Engine Control Module (ECM),
Reprogramming
Cummins ISL
MRU

PI0870, Engine Control Module (ECM), Reprogramming

(August 2016)

W7086759

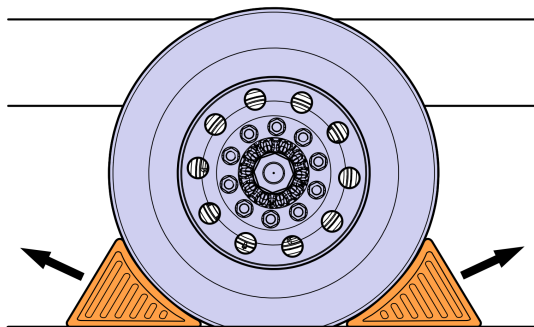
- 7 Select these parameters and change them to the settings in the table below.

New Parameter Settings	
Steps	Settings
a	Go to the Fan Control sections
b	Set the Air Conditioning Pressure Switch Input to “Enable”
c	Set Minimum Fan On Time for Air Conditioning Pressure Switch to “60”
d	Then Go to the SAE J1939 Multiplexing Section
e	Set Air Conditioning Pressure Switch to “Enable”
f	Set Source address to “17”

- 8 Save programmable parameters to the ECM.
 9 Ensure all Cooling Fan and A/C functions work correctly after the parameters are changed.
 10 Clear all Diagnostic Trouble Codes (DTCs) and disconnect from **INSITE**.
 11 Remove the wheel chocks.
